0346- Main Road Dyffryn Cellwen, Neath

Tree Survey Summary - REV A

Tree Survey by Tree Scene, summary by Hickman & Smith Architects

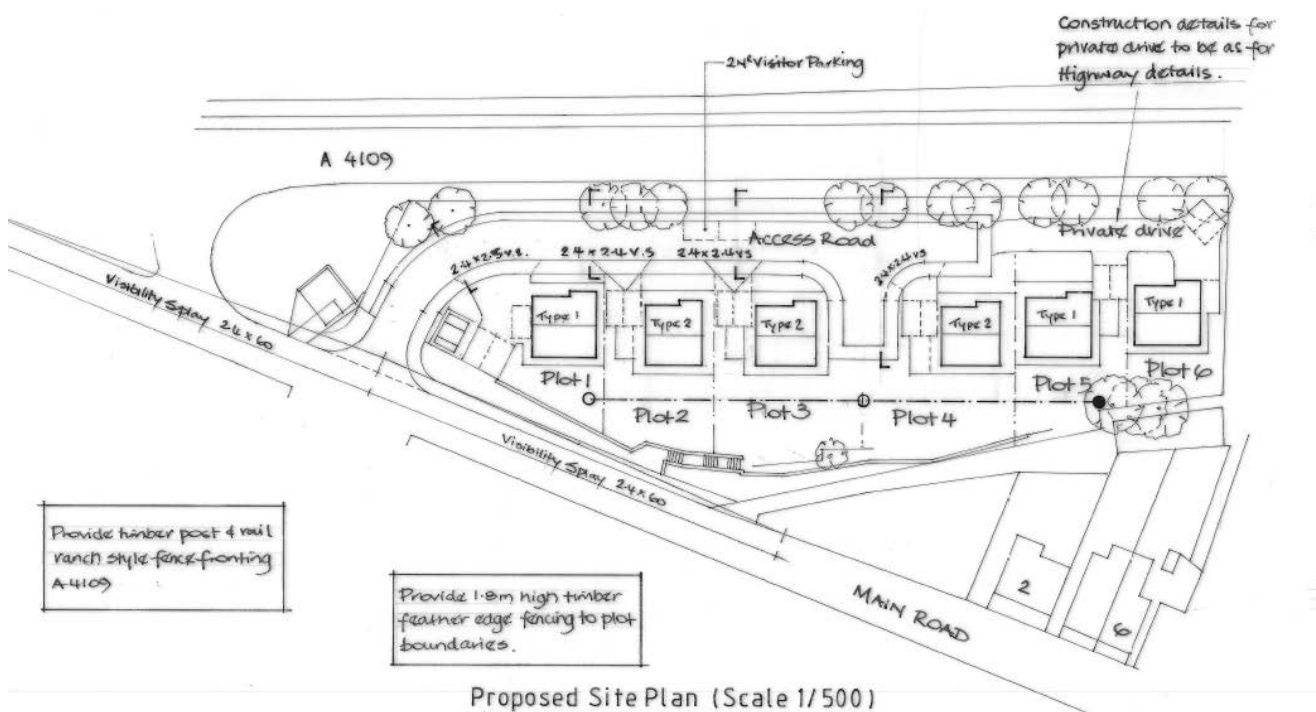
Of those trees the trees highlighted in red were proposed for removal within the tree report due to poor condition (T3, T5, T8, T9) and a further 7 were noted on the approved site plan for removal to facilitate the development (T4, T6, T7, T10, T11, T12, T16) leaving 5 trees remaining on the site (T1, T2, T13, T14, T15).

The approved reserved matters application P2020/0703 then showed the same trees being removed with the addition of T1 as this clashed with the pavement and vision splays required by the council. However, at present this tree still remains on the site.

Original Survey Reference - T1

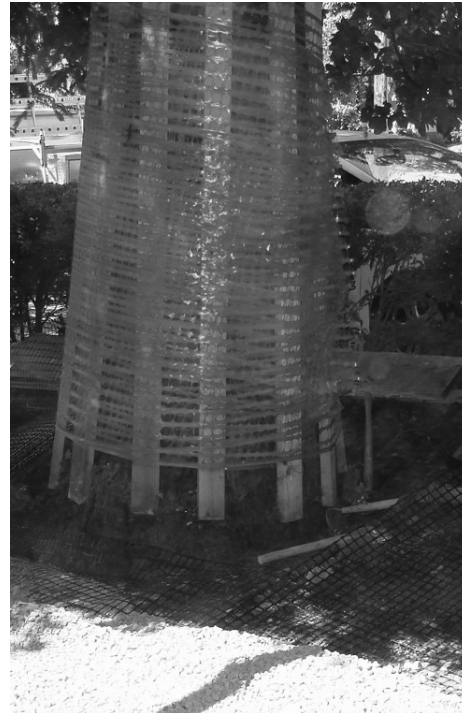
Structural Condition – Good

Suggested Actions – The installation of tree protection fencing is recommended to provide a protective barrier around the perimeter of the tree. Although because of the proximity to the road

the conventional tree protection fencing may not be suited for this particular tree, instead I'd suggest a welded mesh tree guard to go around the trunk of the tree and that it is well secured along with some signage to be cautious of the branches that will overhang the fencing.

If any groundwork is required near the tree, some temporary spray paint to mark out root protection area. Its important that the tree protection used is highly visible with plenty of signage.
